Access Compliance Report

Public Rights-of-Way

(Curb Ramps)

| Intersection ID: 11978 | Main Street: WILSON_AV | Cross Street: BEAUX_ST | Location: S |

| ADA ID: 5CA435EA3610 | Ramp Type: BlendTrans1 | Initial Pass/Fail: Fail | Overall Compliance: No |

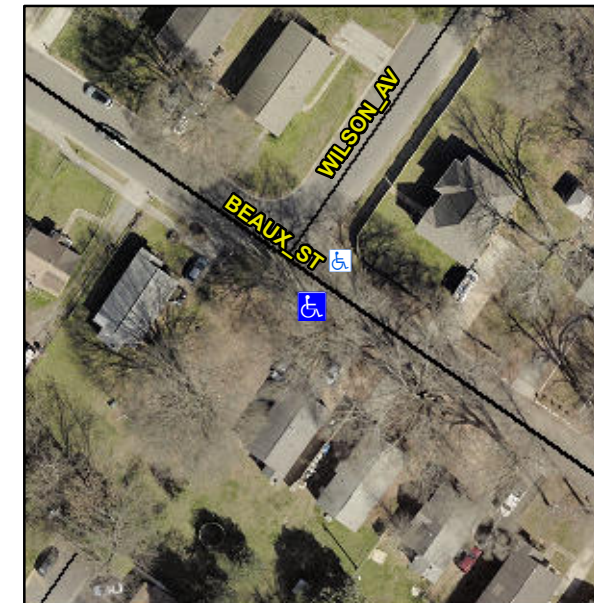
Not Found, R304.5.1

| Compliance | Description | Data | Compliance | Description | Data |
|------------|-----------------------|-------|------------|-----------------------------|------|
| No | Ramp Width (in) | 47.0 | Yes | BlendTrans XSlope (%) | 1.7 |
| | | | No | Curb Slope (%) | 12.1 |

Remove & Replace Curb Ramp With Two New Directional Ramps or Equivalent.
